SUBJECT: KINGSTON STEAM PLANT - ANNUAL POWER ENGINEERING AND CONSTRUCTION AND FOSSIL AND HYDRO POWER JOINT INSPECTION OF THE ASH DISPOSAL AREA

TITLE KINGSTON STEAM PLANT - ALL UNITS - ANNUAL JOINT INSPECTION BY THE DIVISION OF POWER ENGINEERING AND CONSTRUCTION AND THE DIVISION OF FOSSIL AND HYDRO POWER			REPORT NO. FEP-A.SH-88-04	
			PLANT/UNIT KIF-ALL UNITS	
			SAR SECTIONS	
VENDOR	CONTRACT NO.	KEY NOUNS		UNID SYSTEM(S)
	REV	(FOR RIMS USE)	RIMS ACCESSION NUMBER	
APPLICABLE DESIGN DOCUMENTS	R0		B65 '88 0511 001	
	R1			
	R2			
REFERENCES	R3			
	R4

KINGSTON STEAM PLANT

ASH DISPOSAL AREAS

3 DISCHARGE TO INTAKE CHANNEL.

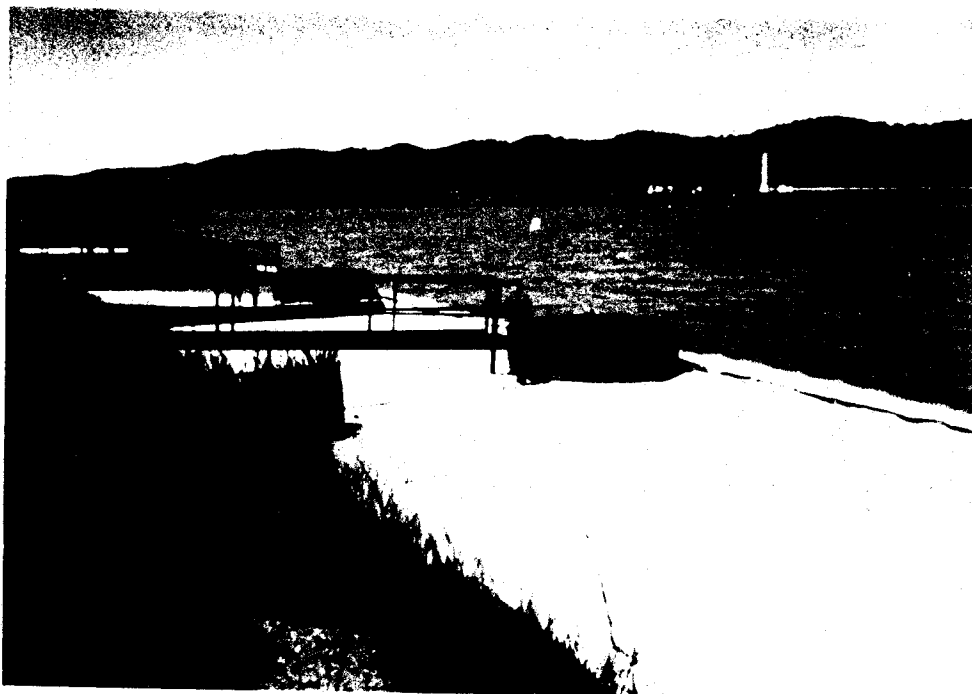
- 4.4 The outlet area for these spillways has a good rip rap cover, and the concrete head wall appears to be in good condition. There was noticeable loss of ash into the plant intake channel. The plant has a floating skimmer in front of the intake structure to skim off the floating ash lost to the intake channel. (See recommendation No. 6.2).

- 6.1 All small trees and brush should be removed from the dike's slopes as needed. It is recommended that this undesirable vegetation be removed by chain or cable as to remove the root system from the earth.
- 6.2 The floating ash within the stilling pool needs to be removed to prevent loss through the spillways.
- 6.3 All limbs and algae need to be removed from the spillway skimmers.

4 FLOATING ASH AND SPILLWAY SKIMMERS.

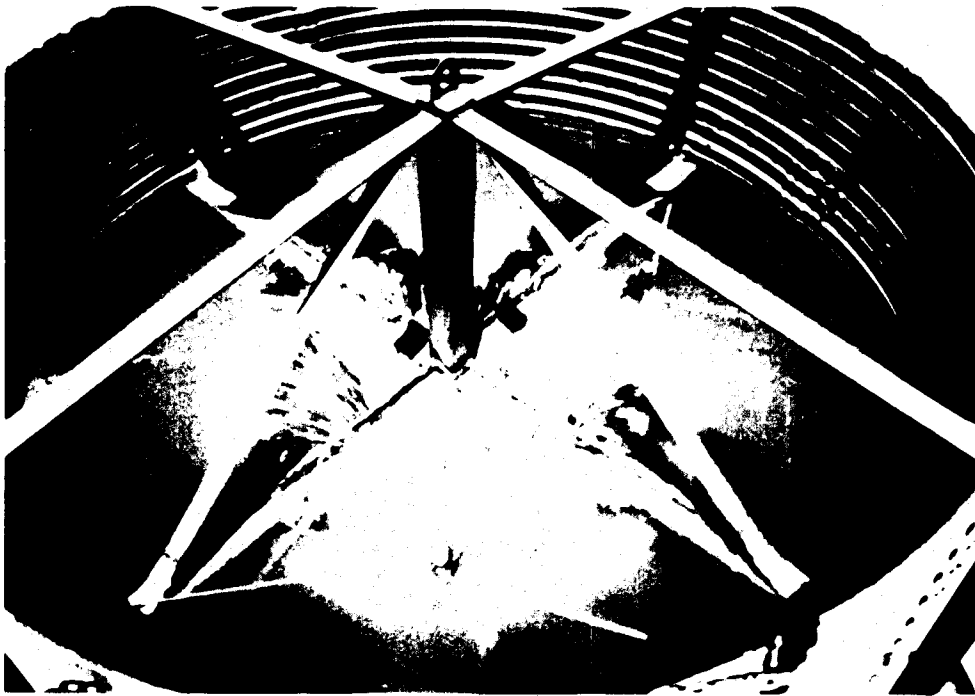
- 4.2 There was a considerable amount of floating ash trapped behind the floating skimmer around the standard spillways and skimmers. Due to this build up of ash, there was a noticeable loss of ash into the spillways (see recommendation No. 6.2).

- 4.3 Five of the six standard spillways and skimmers in the stilling pool area appear to be in good condition and functioning properly. The spillway on the west end has been raised one section higher than the other spillways and is not discharging. Several small limbs and a build up of algae was noticed around the spillways and skimmers which could cause inaccurate discharge readings (see recommendation No. 6.3).
